SERVICE BULLETIN

No. 338

Longitudinal Bulkhead Rivet Installation

PA-31P Navajo

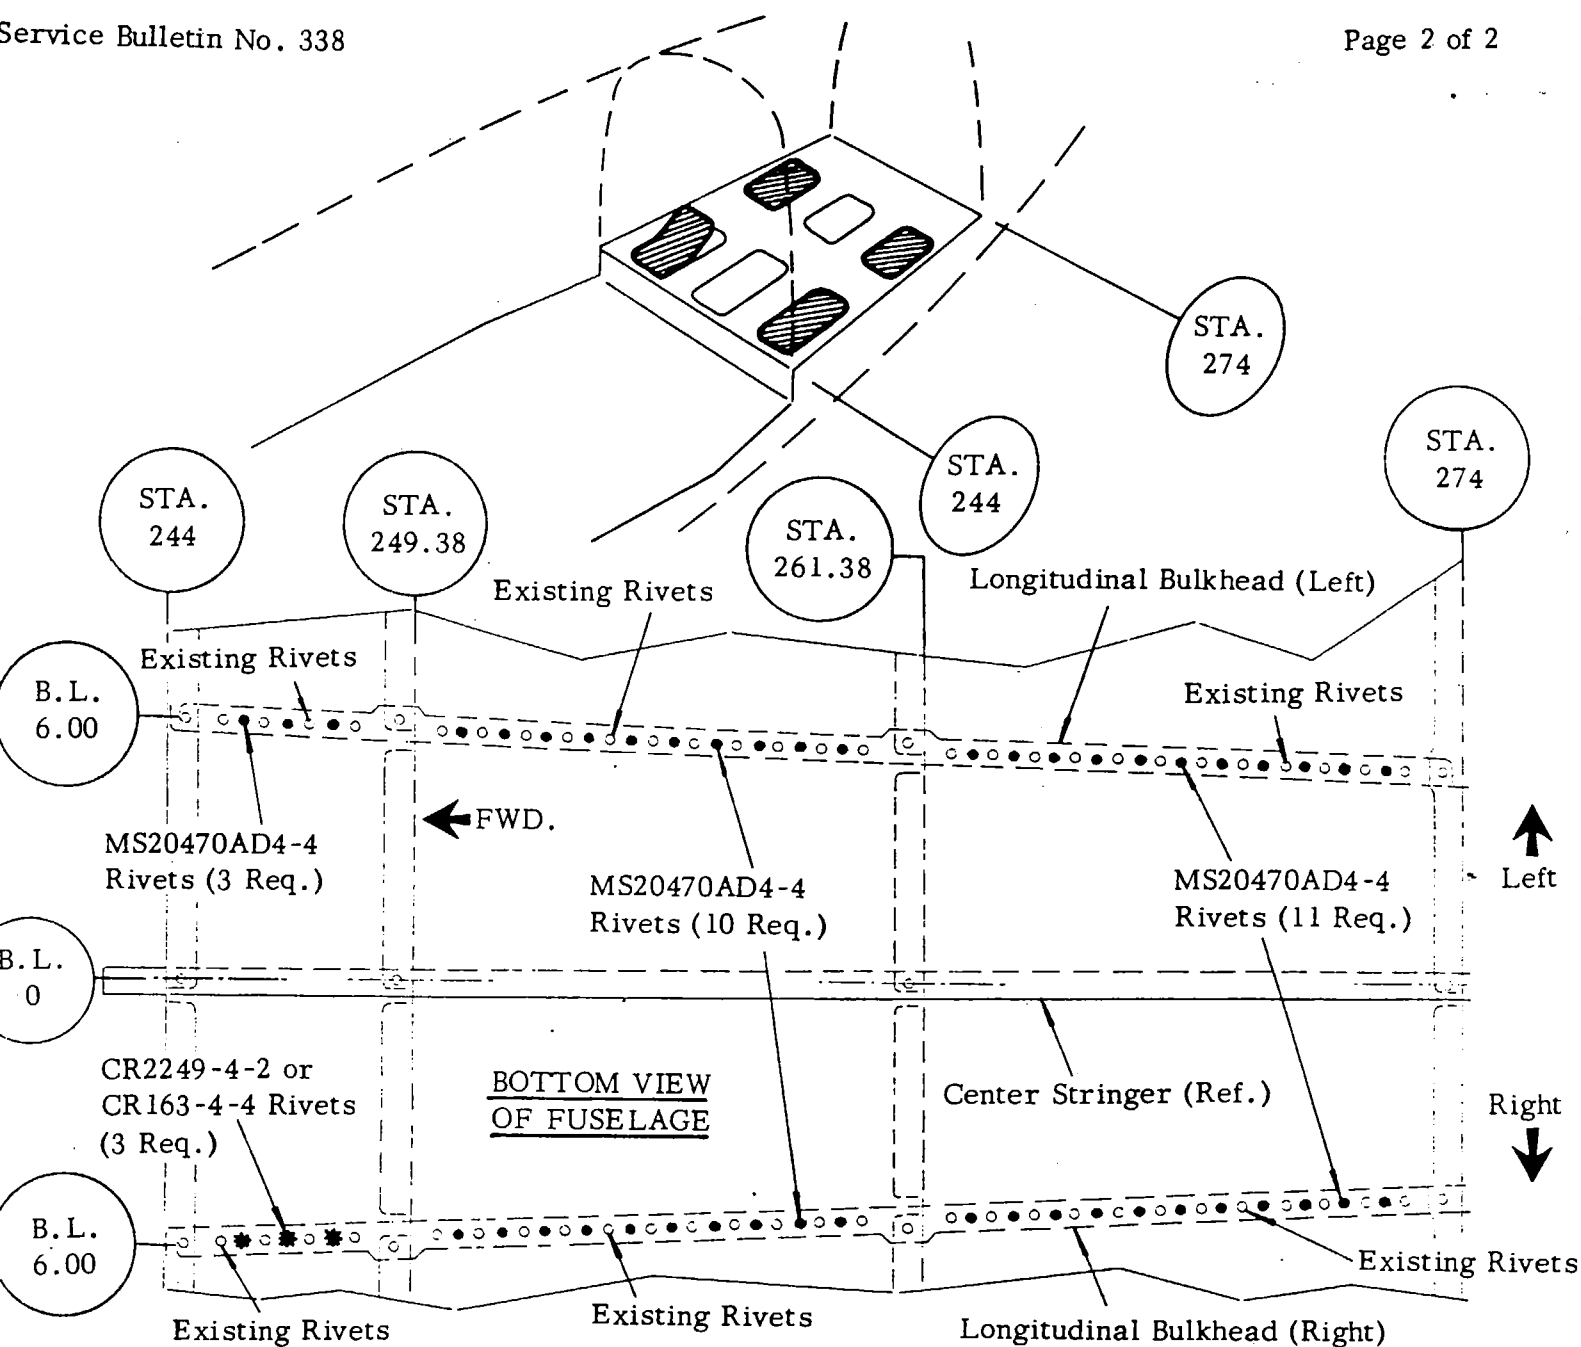
To provide inspection data and, if required, supply material and instructions for the installation of additional rivets on the lower fuselage aft section between the left and right longitudinal bulkheads, fuselage stations 244 to 274; refer to sketch on reverse side of this bulletin for a pictorial description.

1. Inspect the above referenced aircraft in the area referred to on the sketch on the reverse side of this bulletin to determine the type of rivets presently installed.
2. If flush rivets are installed, additional rivets must be installed in accordance with the sketch/instruction data on the reverse side of this bulletin; refer to Material Required, below for rivet identification.
3. If brazier (round-head) rivets have been installed, no further action is required regarding this Service Bulletin.

3. Locate existing flush rivets in bottom skin at left and right longitudinal bulkheads, and draw a pencil line thru center of rivets from Sta. 244 to Sta. 274.

4. On the left longitudinal bulkhead, between Sta. 244 and Sta. 274 and on the right longitudinal bulkhead, between Sta. 249.38 and Sta. 274, mark and drill #30 holes midpoint between existing rivets as shown. On the right longitudinal bulkhead, between Sta. 244 and Sta. 249.38, mark and drill three #27 holes midpoint between existing rivets as shown. CAUTION: Use a drill stop so drill penetration is no more than 1/2 inch.

5. Install forty-five MS20470AD4-4 (P/N 420 216) in the #30 holes and three CR2249-4-2 (P/N 522 882) or CR163-4-4 (P/N 422 897) in the #27 holes as shown.
